December 17 , 2020

Product Change Notice - No side or bottom rivets on 07 series baggage doors

Fig.1 -Rivets

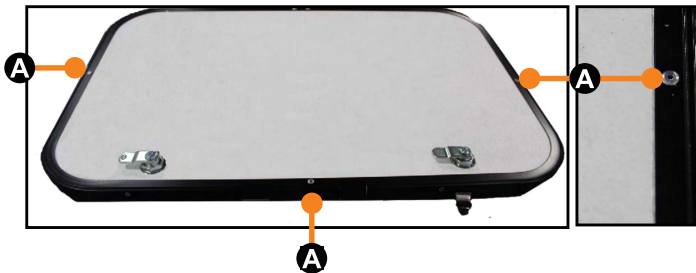
Please be advised, LCI intends to remove the side and bottom rivets (Fig. 1A) from 07 series baggage door frames.

The rivets were originally installed to hold the door core and frame together during the build process as the glue was drying. It was determined that the door spacer blocks (Fig. 3A) used to support the inner frame during the build process serve the same purpose as the side and bottom rivets. The spacer blocks remain in place during the OEM install as well. Please note, rivets will remain in place at the top of the frame to keep the overall frame secure to the core. Only the side and bottom rivets are being removed.

There is no change in fit, function or installation of the baggage doors with the rivet removal. There is no part number change and no price change. The change will be made on a running basis, starting mid-to late January, 2021.
